1984 - 1985 Corvette: Service Bulletin: Improperly Installed Reverse Idler Shaft Roll Pin

Subject: IMPROPERLY INSTALLED REVERSE IDLER SHAFT ROLL PIN

Model and Year: 1984-1985 CORVETTE

Bulletin Number: 85-31 - (01/09/1985)

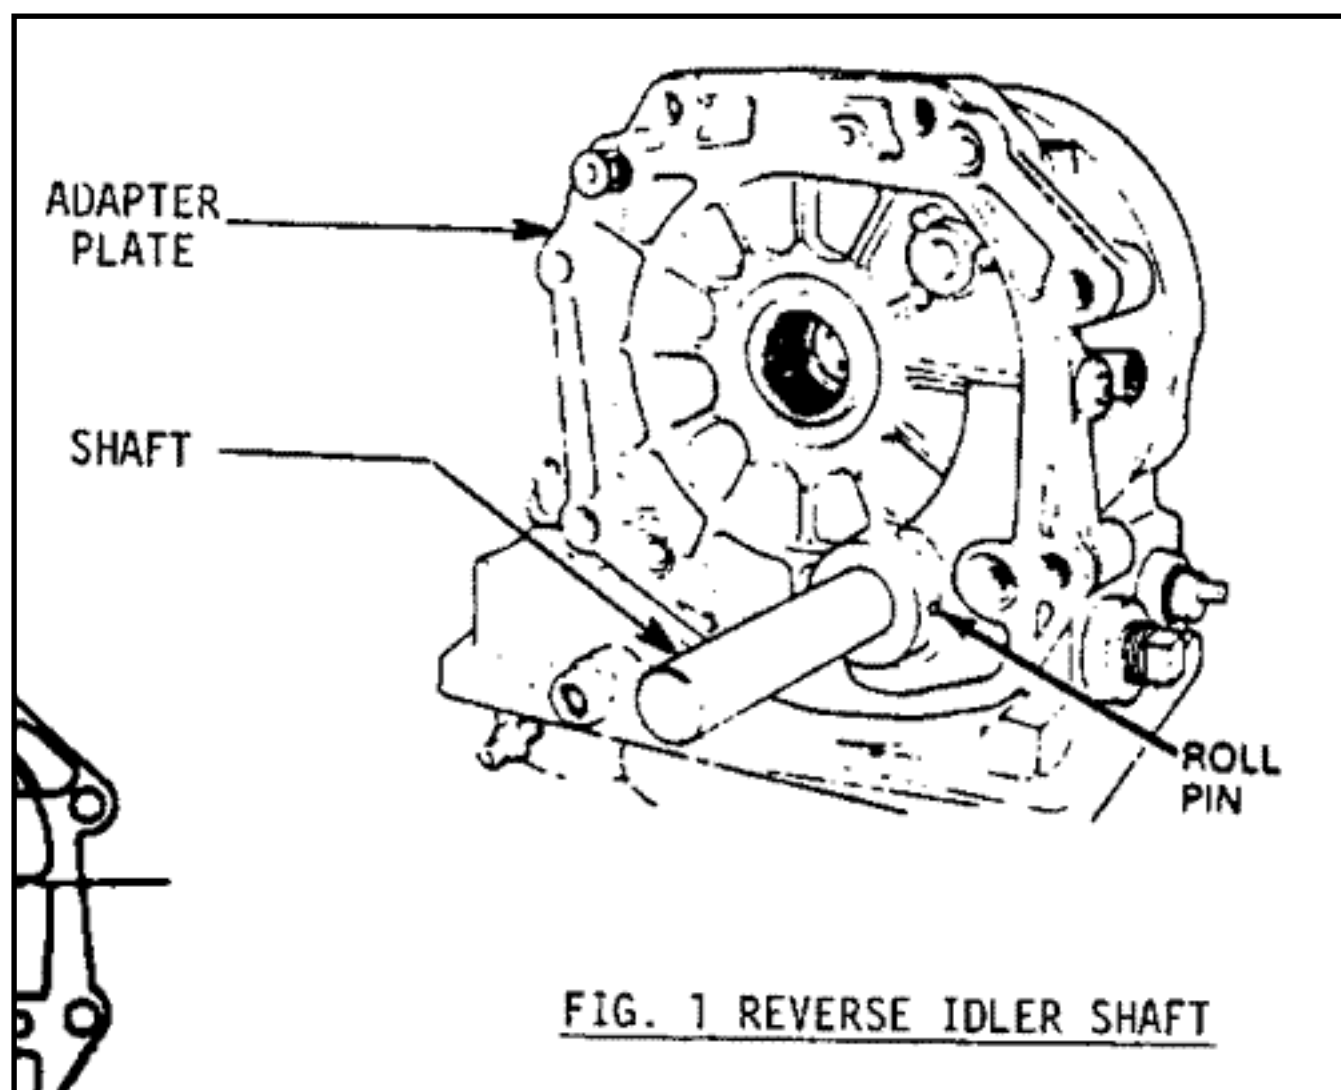
Damage to the manual transmission may occur if the roll pin securing the reverse gear idler shaft to adapter plate (Figure 1) is not fully seated to prevent the shaft from spinning and/or backing out. To insure assembly operation results in the shaft securely locked in place, the roll pin has been lengthened from 0.50" to 0.75". When servicing transmissions with the shorter roll pin (0.50"), discard the roll pin and replace with longer roll pin (0.75") maximum.

1. Insert small punch tool into plate boss hole and carefully drive roll pin into reverse idler shaft (Figure 3).

Driving roll pin too hard may cause to jam and result in shaft binding to adapter plate.

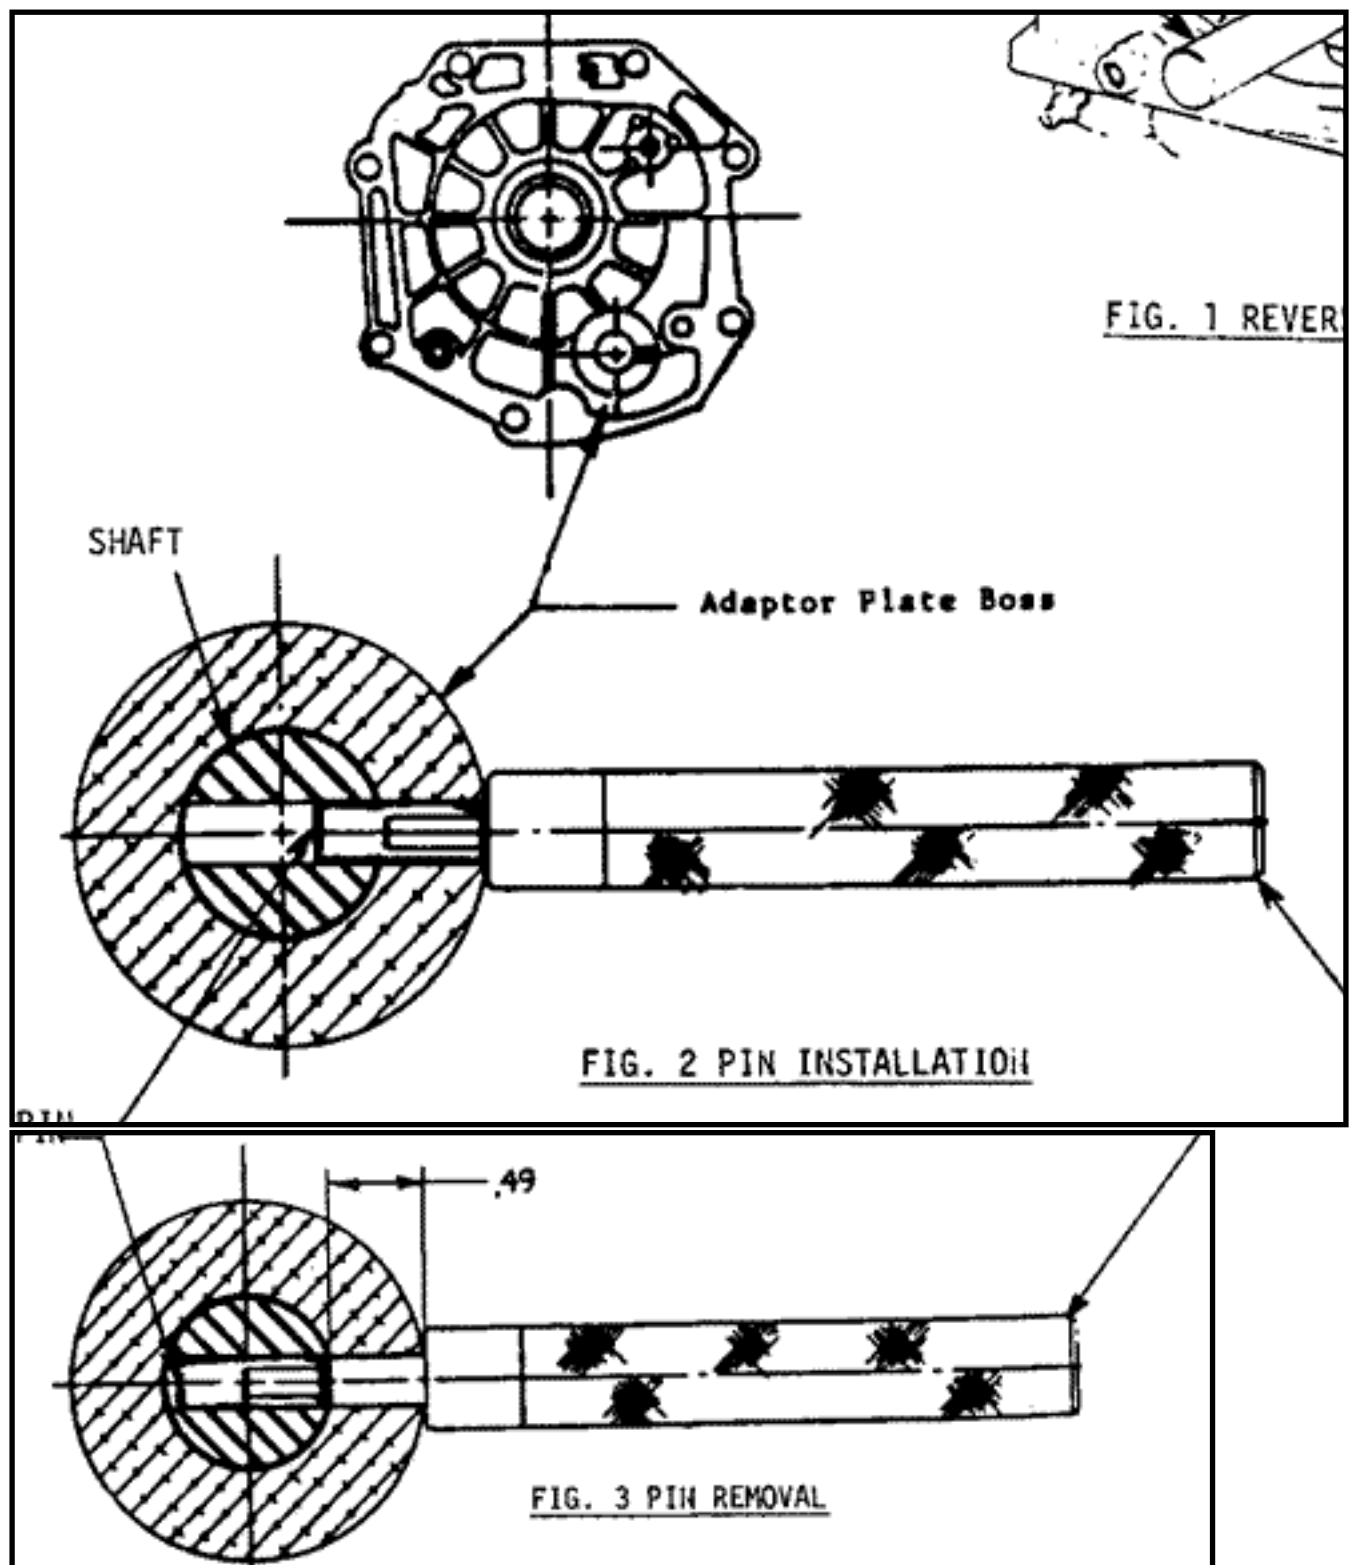
1. Insert reverse idler shaft into adapter plate and align hole in shaft with hole in plate boss.

2. Insert 0.75" roll pin into plate boss hole and, with small punch tool, carefully drive roll pin flush with plate boss (Figure 2).

3. Verify that shaft cannot be pulled from adapter plate.
